HISTORIC AND DESIGN REVIEW COMMISSION

January 20, 2016

Agenda Item No: 31

HDRC CASE NO: 2016-022
ADDRESS: 3248 BROADWAY
LEGAL DESCRIPTION: NCB 3862 BLK 8 LOT 6
ZONING: C2 RIO-1
CITY COUNCIL DIST.: 2
APPLICANT: C&S Wired Up Electric
OWNER: Jim Macani/NTCE BROADWAY PROP LTD
TYPE OF WORK: Channel letter sign
REQUEST:

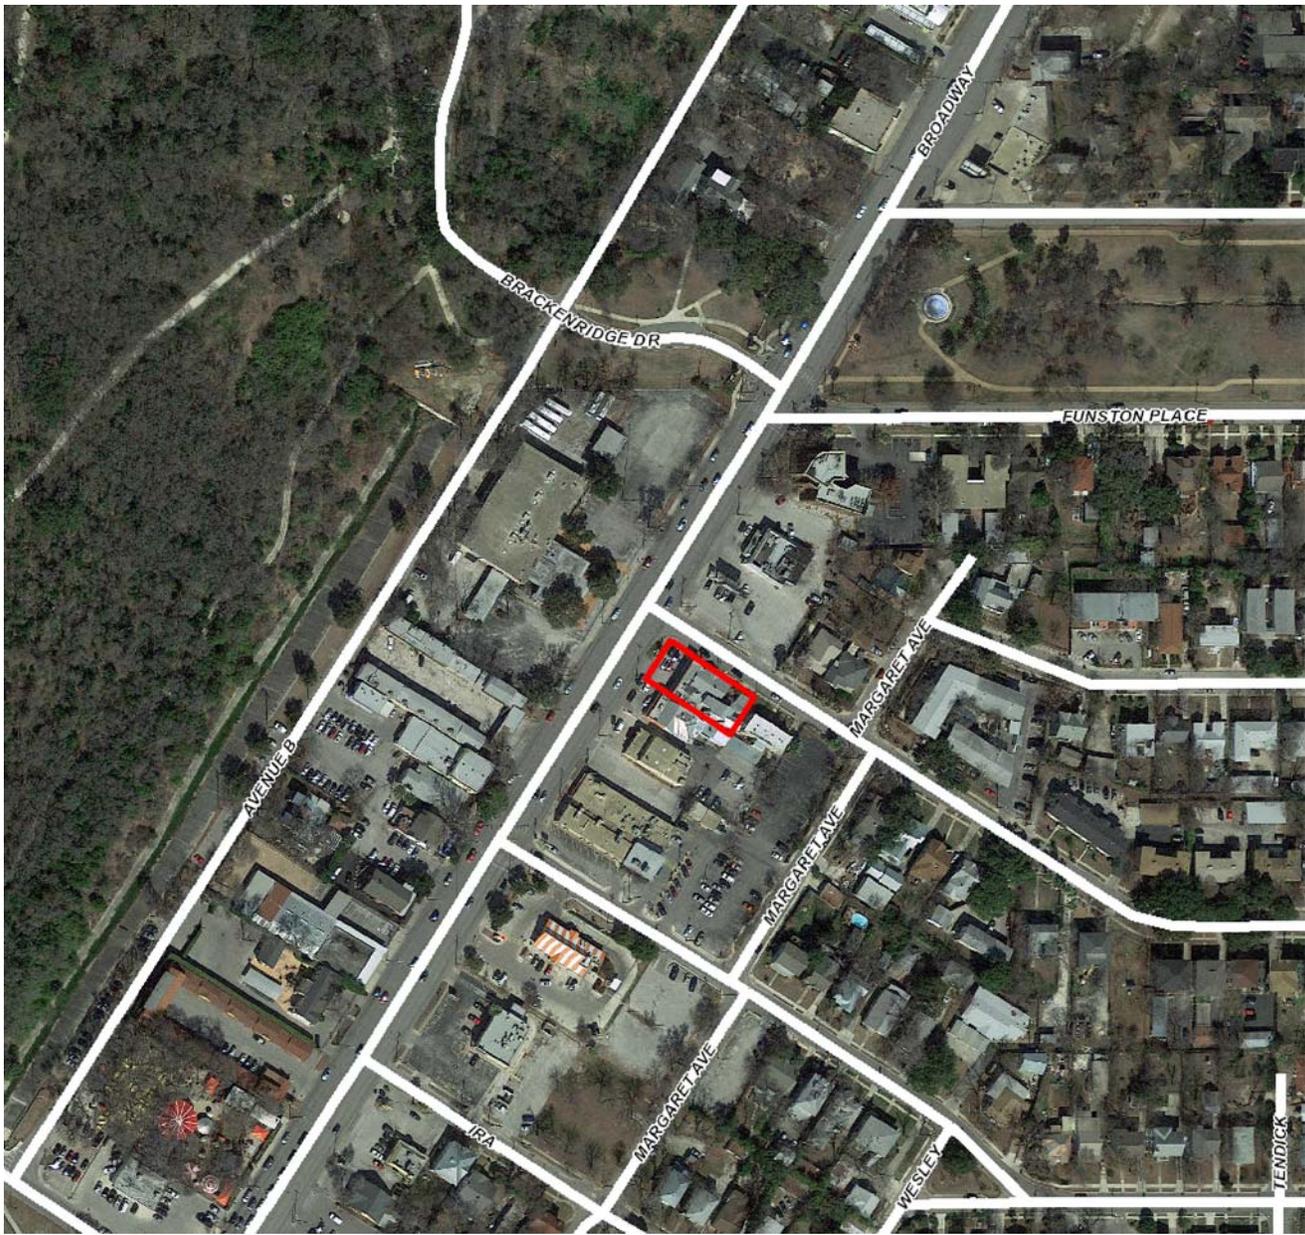
- a. The applicant has proposed to install a channel letter box sign on the existing awning on the street facing façade of the structure at 3248 Broadway measuring 4' in height and 12' – 1" in length. The applicant received administrative approval to reface an existing pylon sign on December 11, 2015.
- b. Per the UDC, total signage for an application may not exceed fifty (50) square feet unless additional total square footage is approved. Staff performed a site visit on January 6, 2015, and found that at this location the material, design and assembly of the sign proposed would be appropriate. The building is a one story, multi-suite structure and there is no justification for additional signage.

Staff recommends approval of the proposed 4' x 12'-1" channel letter box sign materials, design, and assembly with the stipulation that the overall size of the sign be reduced and the applicant submit new mock-up for staff to approve.
